**Addendum #4 dated April 27, 2021
Contra Costa Water District, Request for Proposals #2139
HVAC Replacement at Antioch Service Center
Questions and Answers**

The District draws your attention to the following questions and answers to Request for Proposal #2139, the questions and answer are hereby made an official part of this proposal and are outlined below:

ANTIOCH SERVICE CENTER

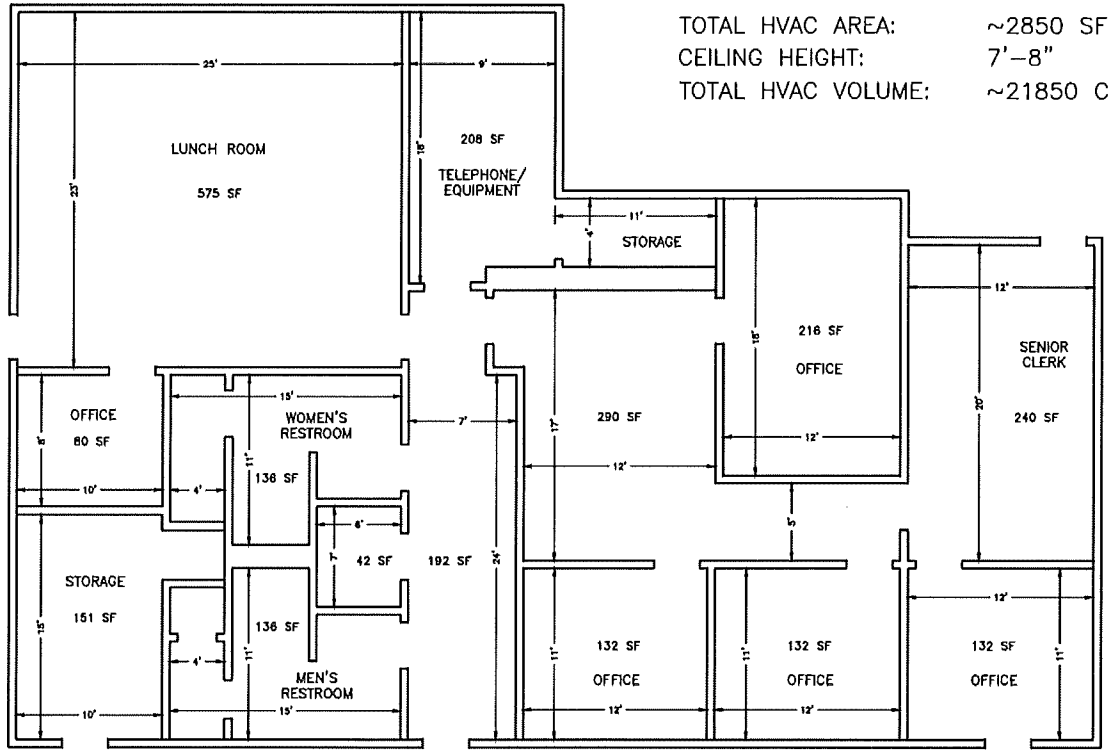
8. I would like a building floor plan

Answer: see floor plan below

TOTAL HVAC AREA: ~2850 SF
CEILING HEIGHT: 7'-8"
TOTAL HVAC VOLUME: ~21850 CF

more photos of the attic

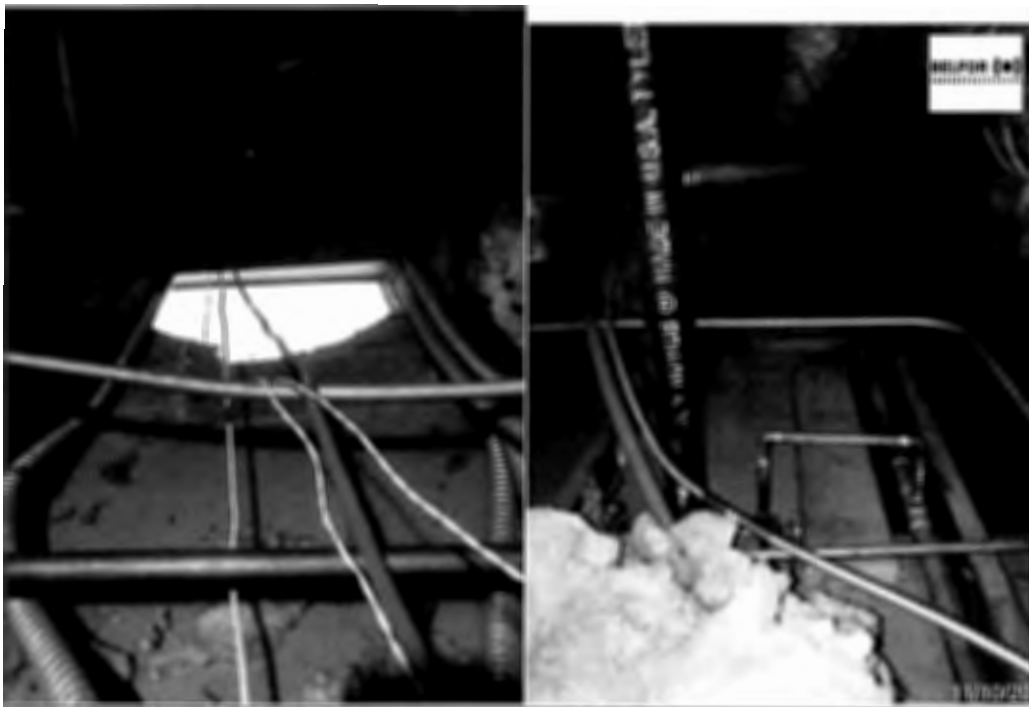
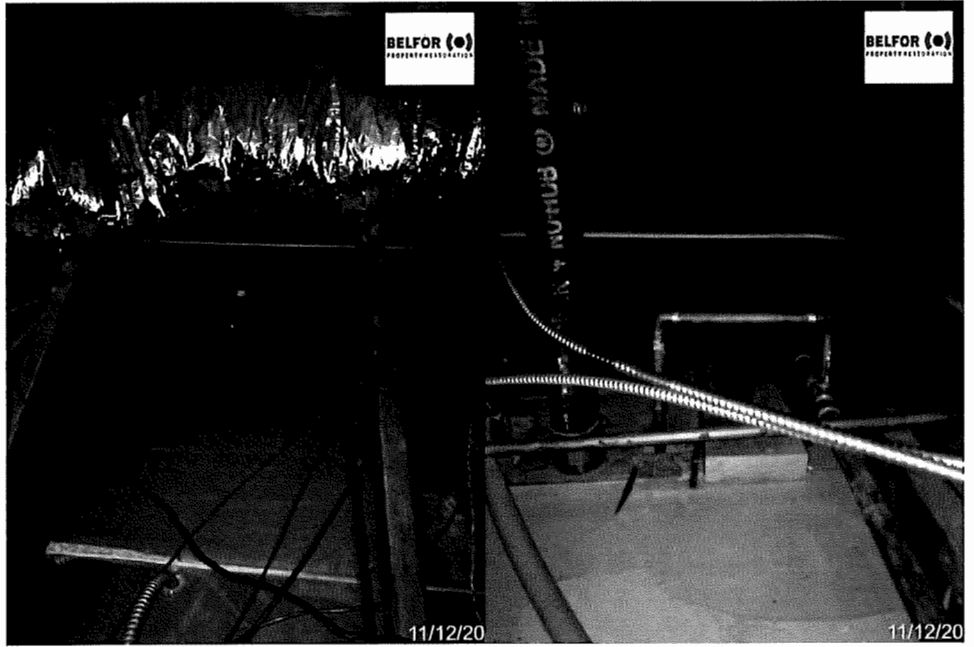
9. Are there additional building as-builts or duct work as-built or shop drawings?

Answer: No, however eight photos of the attic are included below.
